BRK15HDMV2 Datasheet
 Product Revision: Rev A

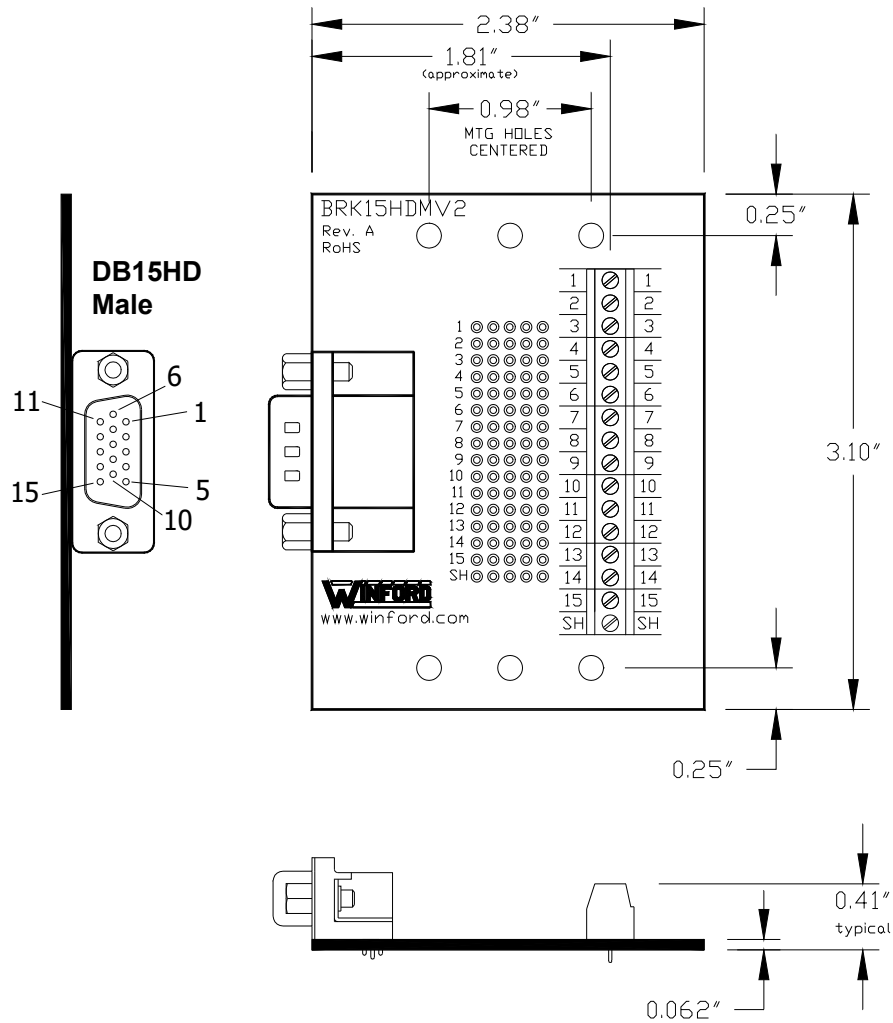
Date	Description
03/01/2012	<p>Product V2, Rev A Changes:</p> <ul style="list-style-type: none">• Brought DB15HD Shield/Shell connection out to new solder pads and screw terminal• Slightly shifted screw terminals away from edge of PCB• Shifted mounting holes / DIN clips towards PCB edge by 0.05", both sides• Moved solder pad grid closer to DB15HD connector• Silkscreen number labels by screw terminal: larger print, added on back side, added dividing lines• NOTE: Board size remains unchanged
